Southern Water

Your Ref: APP/12/00053

Our Ref: PLAN-000432

Proposal: Single storey extensions to northern and southern wing and front elevation to provide 8No. additional resident bedrooms.
Site: 54 Stockheath Road, Havant PO9 5HQ.
APP/12/00053

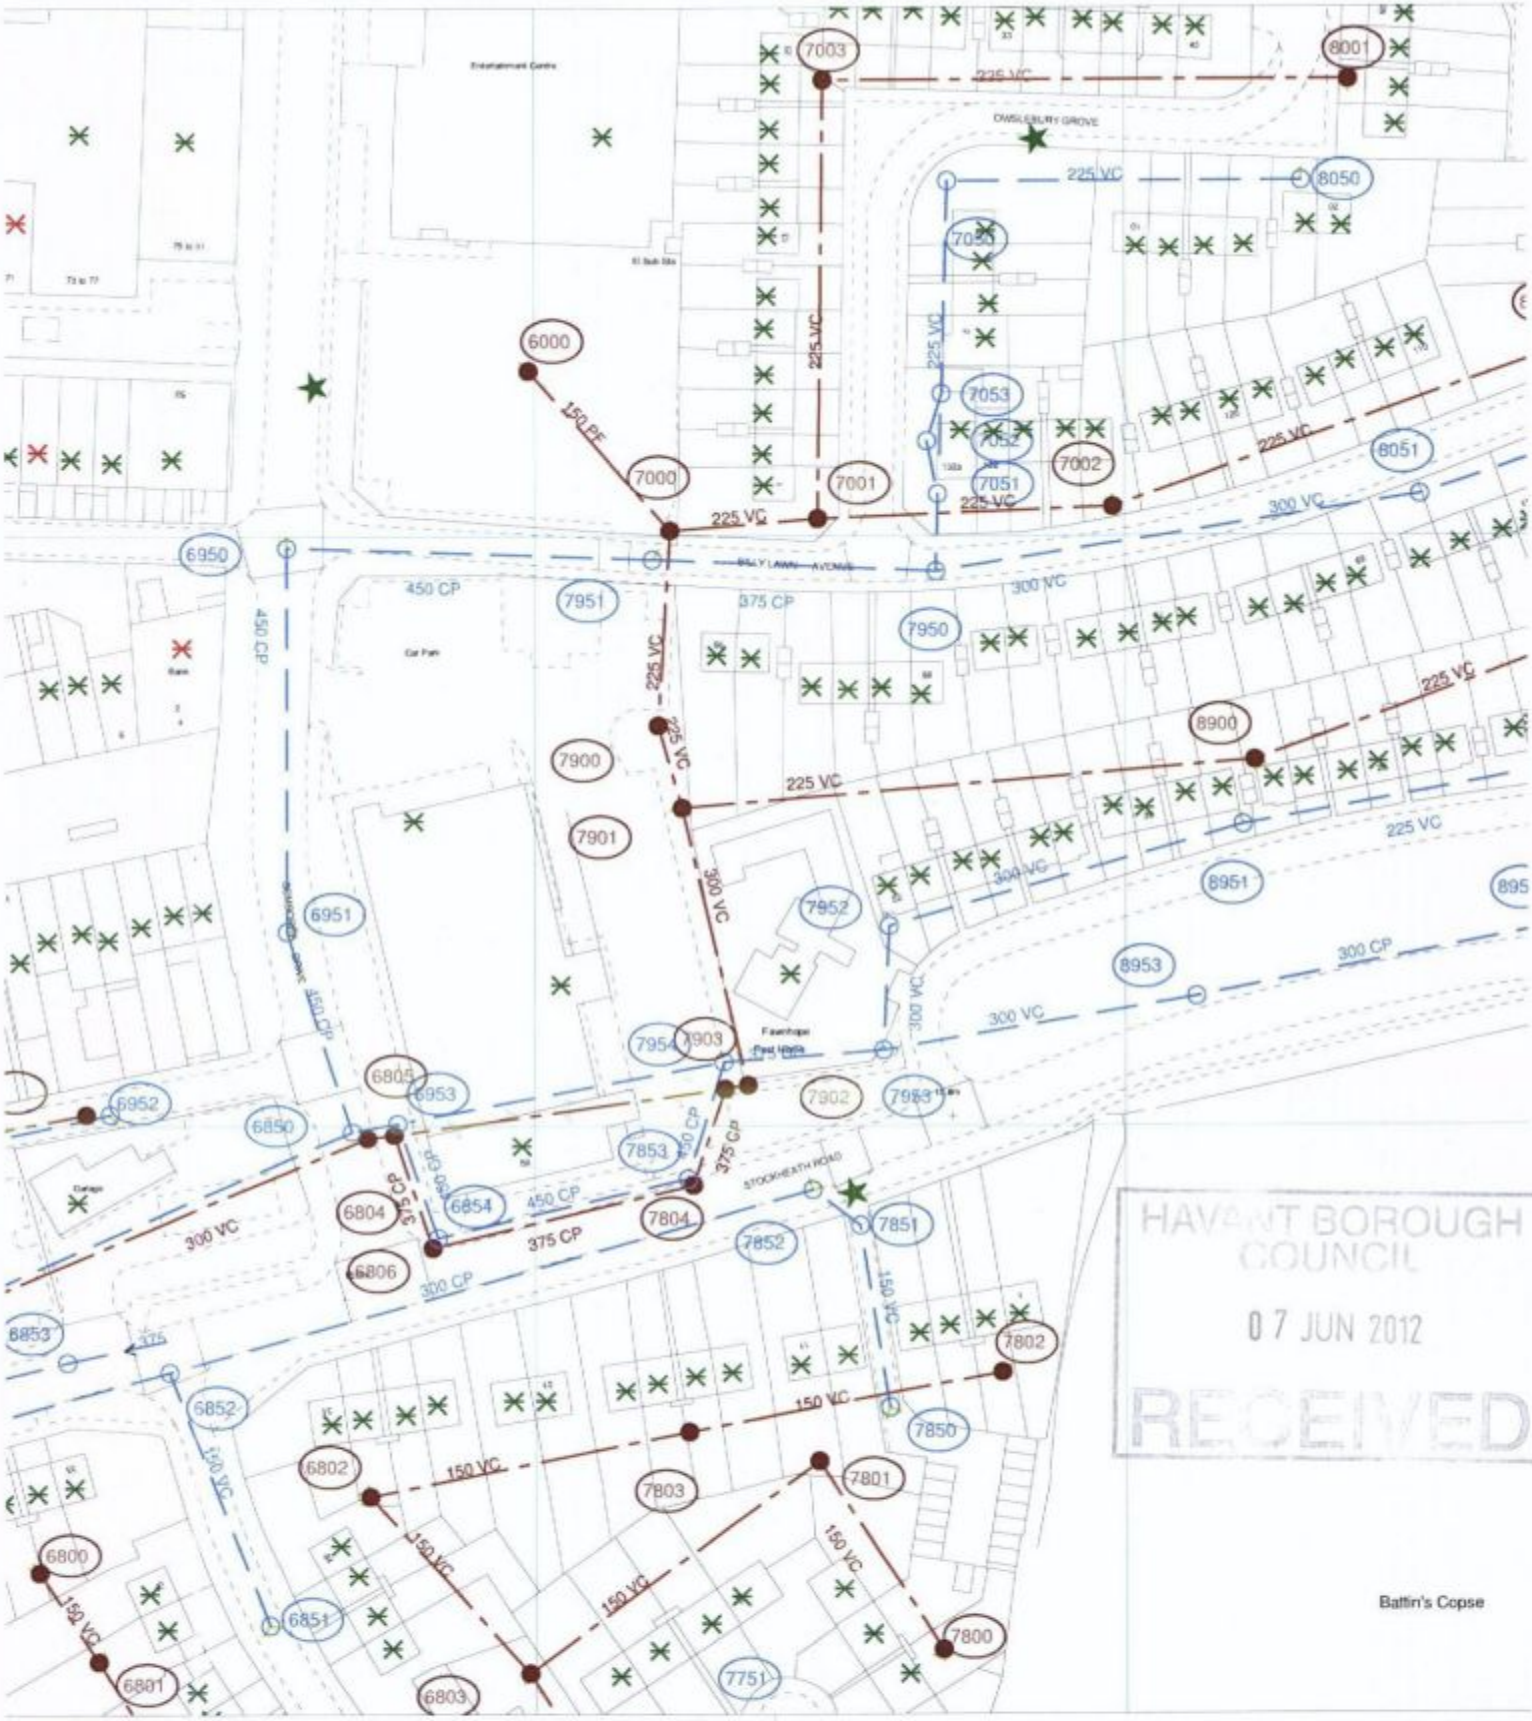
Please find attached a plan of the sewer records showing the approximate position of foul and surface water sewers crossing the site. The exact position of the foul and surface water sewers must be determined on site by the applicant before the layout of the proposed development is finalised.

It might be possible to divert the surface water sewer, so long as this would result in no unacceptable loss of hydraulic capacity, and the work was carried out at the developer's expense to the satisfaction of Southern Water under the relevant statutory provisions.
Should the applicant wish to divert apparatus:
1.The 375 mm diameter surface water sewer requires a clearance of 3 metres either side of the sewer to protect it from construction works and allow for future access for maintenance.
2.The 300 mm and 225mm diameter foul sewer requires a clearance of 3 metres either side of the foul sewer respectively to protect it from construction works and allow for future access for maintenance.
3.No development or new tree planting should be located within 3 metres either side of the centreline of the foul and surface water sewers respectively.

4.No new soakaways should be located within 5m of a public sewer.
5.All other existing infrastructure should be protected during the course of construction works.

In order to protect drainage apparatus, Southern Water requests that if consent is granted, a condition is attached to the planning permission. For example "The developer must advise the local authority (in consultation with Southern Water) of the measures which will be undertaken to divert/protect the public sewers, prior to the commencement of the development."
